ftem ID: D212-664-201 Accept Setup Start **Revision ID:** Item Name: Crosstube Aft **Start Date:** 11/06/2012 Start Qty: 1.00 **Cust Item ID: Required Date:** 05/07/2012 Req'd Qty: 1.00 **Customer:** Reference: Run Process Plan: MLJ Approvals: Date: 12/06/11 **Tooling:** Stop Date: SPC (Y/N): Date: Sequence ID/ **Operation** Set Up/ Tool ID Tool # Plan Reject Reject Accept Insp. **Work Center ID** Description Code Qty Qty Number **Run Hours** Stamp Draw Nbr **Revision Nbr** D212-664-241 Rev D (DEO) DS19563 В 100 0.00 DOCUMENT CONTROL *100* DC 0.00 Memo Document Control Photocopy bluefile and create labels as per PPP D212-664-201 110 Pick Kit 0.00 Packaging Packaging 0.00 Memo

NCR:	-1759	W	ORK OR	ORK ORDER NON-CONFORMANCE (NCR)					
		Description of NC		Corrective Action Section B	· ·	Verification	Approval	Approval	
DATE	STEP	Section A	Initial Chief Eng	Action Description Chief Eng	Sign & Date	Section C	Approval Chief Eng	Approval QC Inspector	
8/02/30	# 170	tuly has higen crushing albuss for Dung. R.C. Prouss.		Meatall per Email Fram Dains. Aug 7M, 2012. Ber Ottachin		1 745 196 07		(PAS) 16, 16,

Subject: Attachments: RE: D212-664-201 again 20120807114006168.pdf

DART AEROSPACE LT

SECTION A-A

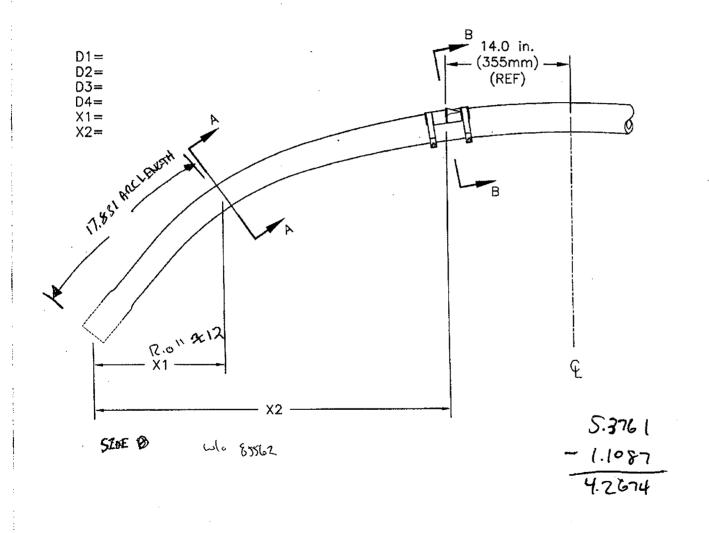
Your methodology is good, but I believe your inertia calculation for the ellipse is wrong. You need the smaller inertia value since the tube is the flattened in the direction that it is loaded.

I have another D212-664-201 B85562 cross tube with the crushing out of drawing tolerance. As you can see in the attachment that **side A** has a crushing of **7.3% at 6 passes** and **side B** has a crushing of **7.5% at 10 passes**. They were both measured at about 16" from cuffs.

Lo Average diameter, assume rand, measured by hand by Eric, verified by Alex.

I have reviewed Alex's analysis and there are a few mistakes, but I believe this tube is acceptable. Please attach the attached modified analysis to the work order and get Alex to sign for the deviation.

OA= 12P YA = 128 (2.530/2) 1.7862 1.3886 8-4984 P 10.932

MARCYN OF JAFETY

SIDES ARE ACCEPTABLE

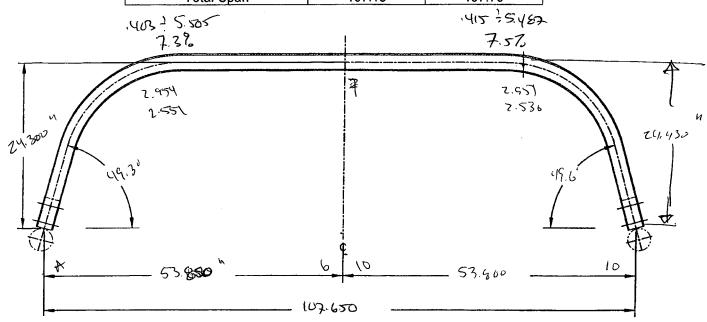
Comments						
Sinc 1	チュ	7.3%	crushin	6	Passe.	
MUDDY	٠.	7-04xe	2 .			
Sive B	2	7.572	crushs	Q lo	0920

FIGURE 1: SUPPORT INSTALLATION

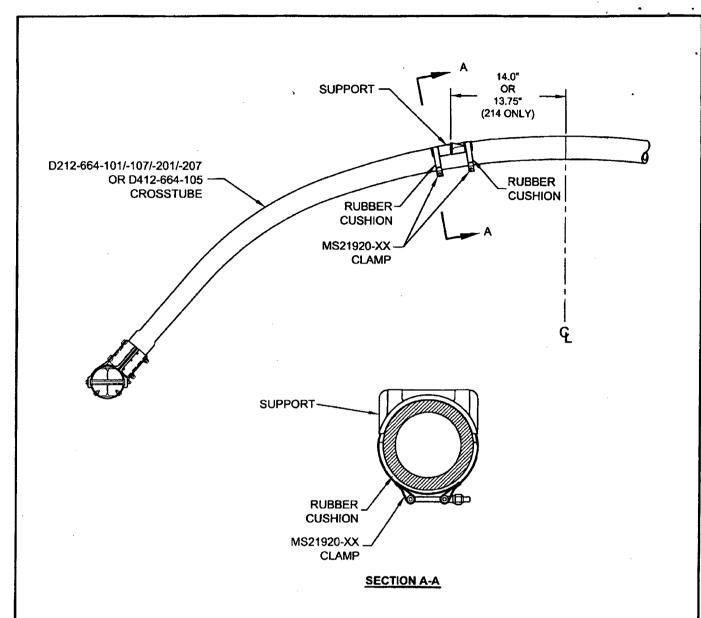
The supports on the following crosstubes are now installed using Proseal instead of Magnobond:

- 32.4.6 Install the clamps opposite to crosstube support as shown in section A-A of Figure 1. Install rubber cushions underneath each clamp around the bottom circumference of the crosstube up to the crosstube centerline. Torque clamps 80-100 in the (9.0-11.3 Nm). It is acceptable to use smaller or larger sized MS21920-XX clamps than those listed in ICA-D212-664, ensure that after torquing the clamps per this instruction, the nuts are in safety but not bottomed out

- 32.4.5 Apply a 0.04" to 0.07" thick layer of Proseal 890 Class B or AMS-S-8802 Class B sealant underneath applicable support and install support as shown in Figure 1 of this service instruction.
